SERVICE INSTRUCTION no. 2017/01
Increasing of Slide vent deflation system efficiency

With reference to: Kubicek envelopes BB34(Z,D,N)-BB45(Z,D,N) equipped by Slide vent
Note: This modification is incorporated by the manufacturer for more recent envelopes.

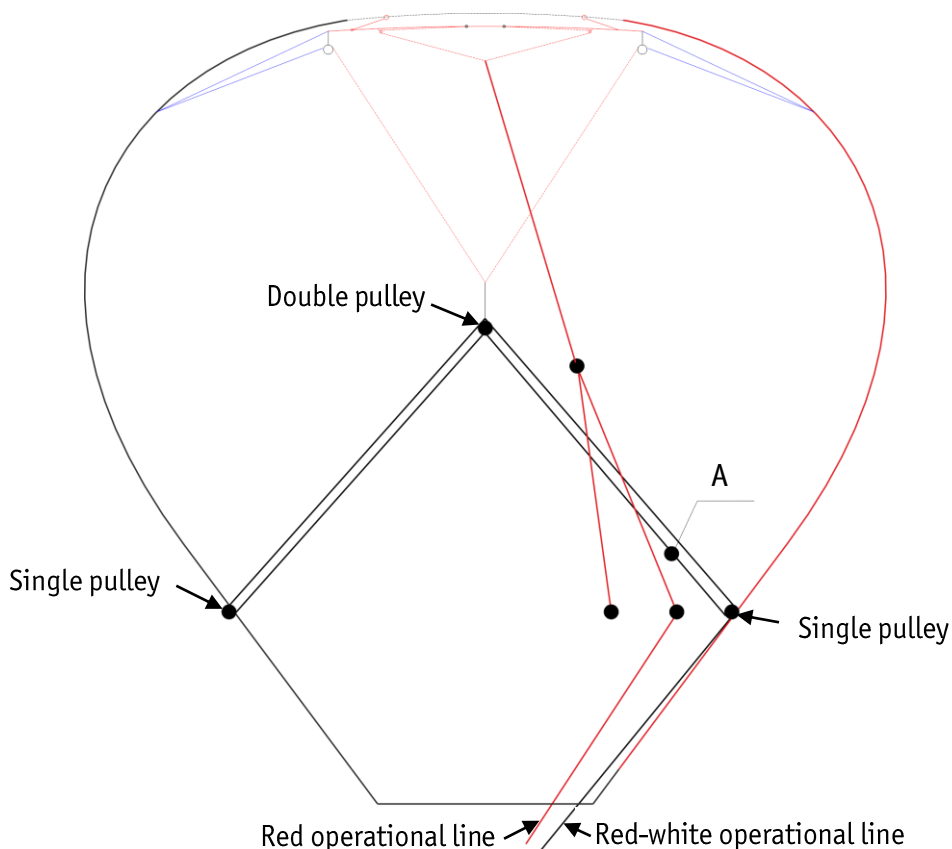
1. Untie the red-white operational line in point A (see following picture), shorten the red-white operational line by cutting off the length defined in table:

Type	Cutting length (m)
BB34(Z,D,E)	12
BB37(Z,D,N)	11
BB40(Z,D,N)	11
BB42(Z,D)	14
BB45(Z,D,N)	14

Before:

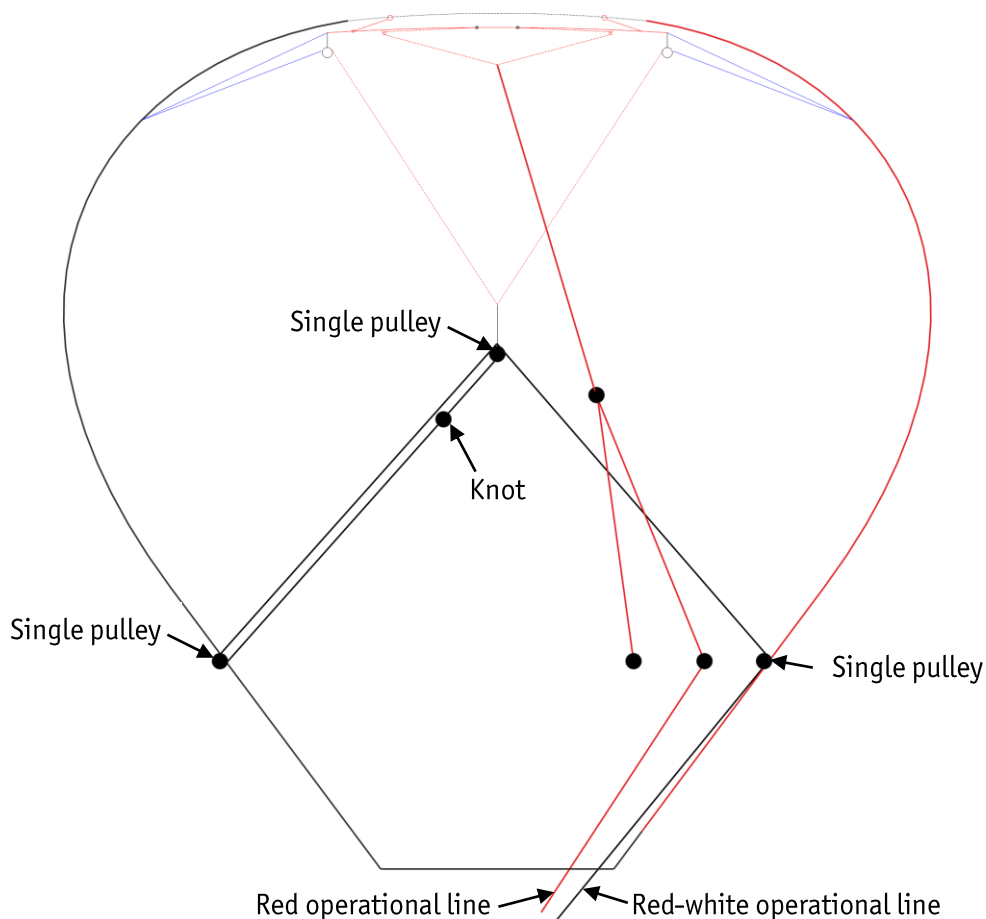
2. Pull out the line from the pulleys. Replace the double pulley with single pulley.
3. Pull the line through the pulleys and tie.
